## Product Change Notification / LIAL-16UCZH910

CCB 4732 Final Notice: Qualification of MMT as an additional assembly site for selected MCP6031, MCP6033, MCP6002, MCP6231 and MCP6241 device families available in 8L DFN (2x3x0.9mm) package.

**CCB 4732**  
**Pre and Post Change Summary**  
**PCN#: LIAL-16UCZH910**

# Lead frame comparison

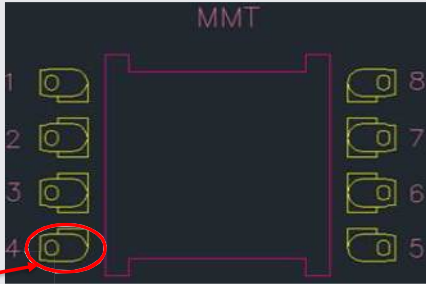
Lead frame material	EFTEC-64T
Lead frame DAP surface prep	Ag
Lead frame lead-lock	No

Lead frame material	C194
Lead frame DAP surface prep	Bare Cu
Lead frame lead-lock	Yes

NOTE: Mold compound material fills the [lead lock hole](#), which provides improved protection against moisture penetration along the edge of the leads (pins) of the package.
